**LLOYD STATION SUBDIVISION, INDUSTRIAL
DEVELOPMENT VENTURE, FIRST ADDITION,
RESUBDIVISION OF LOTS 4 & 5**

The preliminary plat illustrates the proposed 2-lot, 2.1± acre subdivision which is located on the North side of Alden Drive, 80'± East of McMurray Lane, within Council District 4. The applicant states that the subdivision is served by city water and sanitary sewer systems. The purpose of this application is to relocate an interior lot line between two existing legal lots of record.

DETAIL SITE PLAN

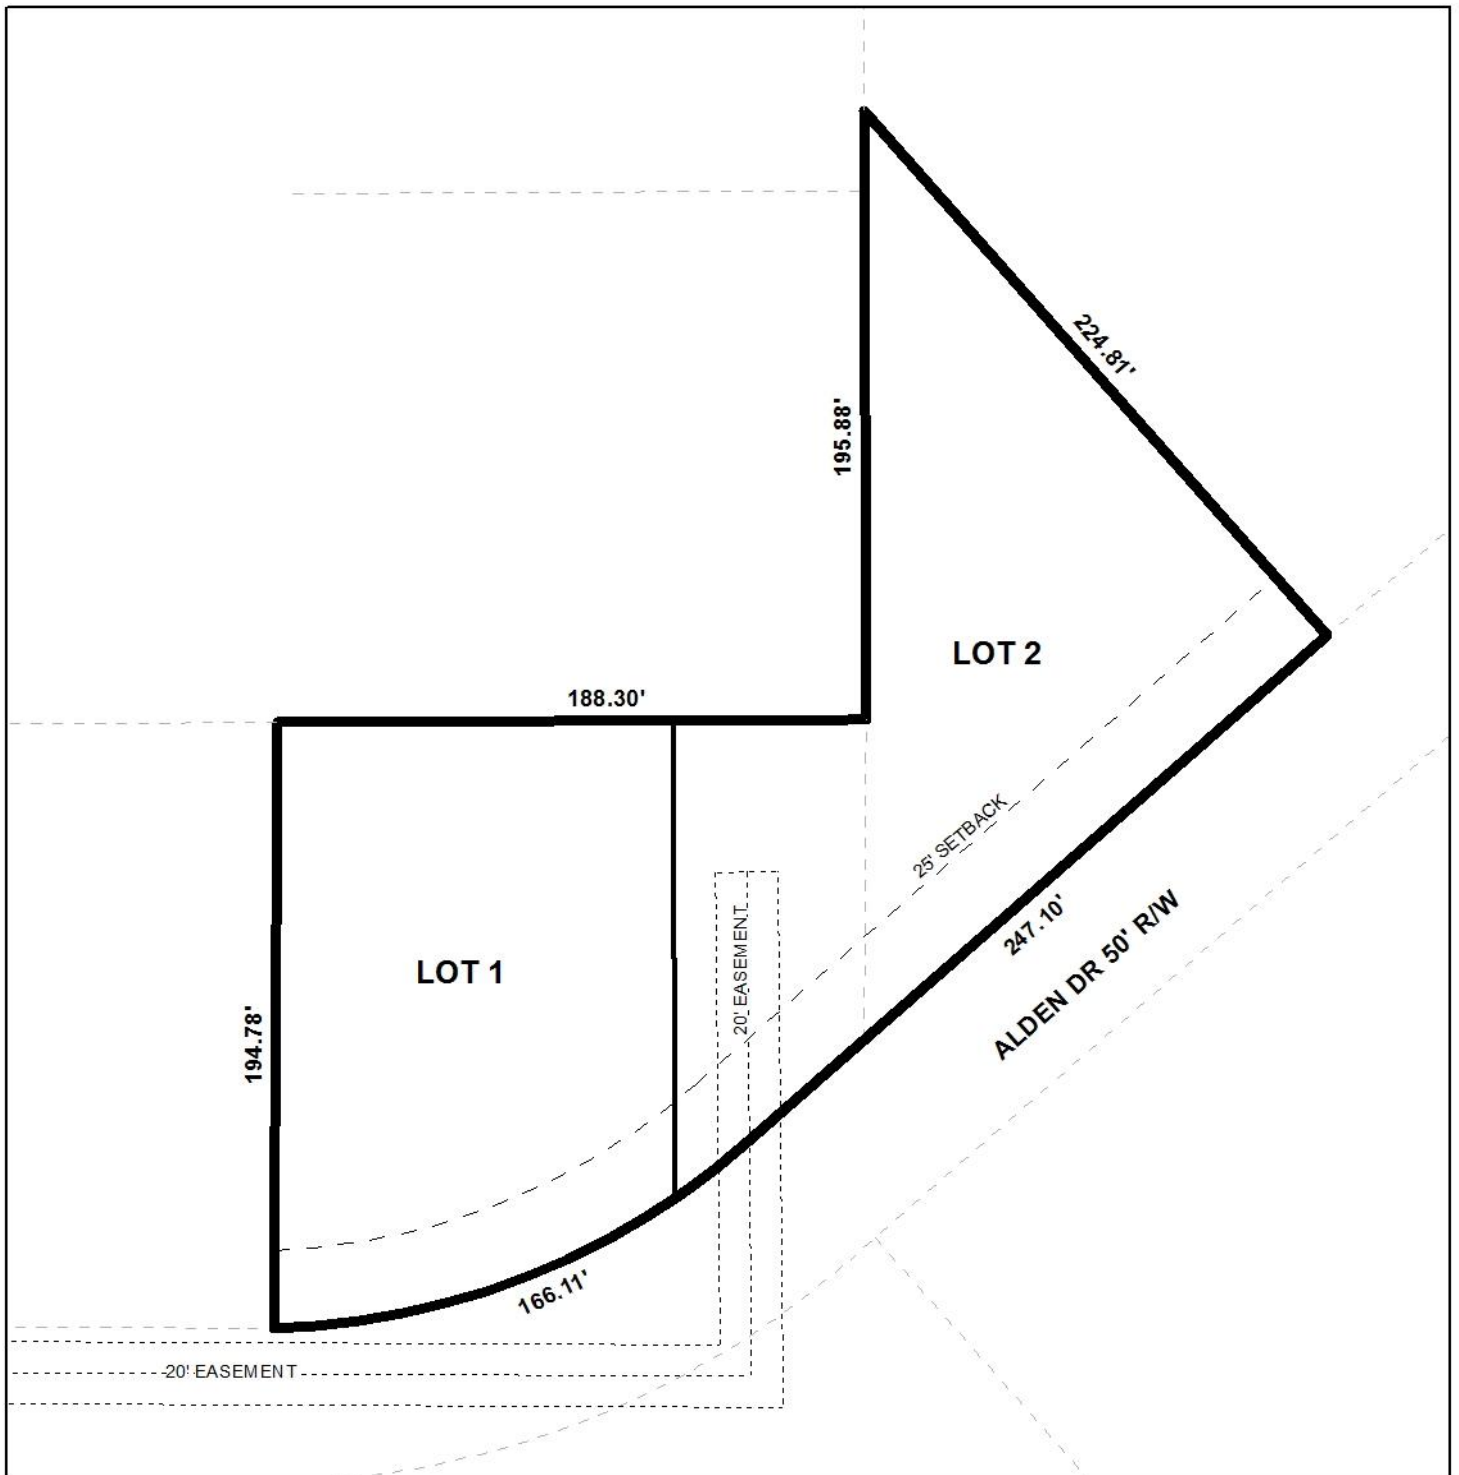
The proposed lots are a part of the Lloyds Station Industrial Development Venture 1st Addition which was approved in 1996. On the 1996 plat, there is a 20' roadway and sanitary sewer and waterline easement located on Lot 4. The preliminary plat illustrates the inclusion of the 20' roadway and sanitary sewer/ water line easement in the proposed Lot 2. It should also be noted that the 1996 recorded plat illustrates a sewer lift station where the 20' easement ends on Lot 4. If approved, a note should be placed on the Final Plat stating no structures will be placed in any easement.

The proposed lots front Alden Street, a minor street with curb and gutter. As a minor street, Alden Street requires a 50' right-of-way width as depicted on the preliminary plat. If approved, the 50' right-of-way width should be retained on the Final Plat.

A 25-foot minimum building setback line is depicted on the preliminary plat along Alden Street for the proposed Lots 1 and 2. If approved, the 25' setback along Alden Street should be retained on the Final Plat.

The proposed Lot 1 is depicted as 23,082± square feet and the proposed Lot 2 is depicted as 30,005± square feet; both of which exceed the 7,200 square foot minimum lot size requirements for lots served by public water and sanitary sewer systems. The preliminary plat provides the lot sizes in both square feet and acres and if approved, the lot size information should be retained in both square feet and acres on the Final Plat.

As a means of access management, a note should be placed on the Final Plat, if approved, stating that Lot 1 is limited to one curb cut and Lot 2 is limited to two curb cuts, with the size, design and location of the curb-cut to be approved by Traffic Engineering and conform to AASHTO standards.

- 1) Retention of the 25' minimum building setback line along Alden Street;
- 2) Retention of 50' right-of-way width for Alden Street;
- 3) Retention of the 20' roadway and sanitary sewer/ water line easement on Lot 2;
- 4) Placement of a note stating no structures will be placed in any easement;
- 5) Retention of lot size information in both square feet and acres;

- 6) Placement of a note on the Final Plat stating that Lot 1 is limited to one curb cut and Lot 2 is limited to two curb cuts, with any changes in the size, design and location to be approved by Traffic Engineering and conform to AASHTO standards.
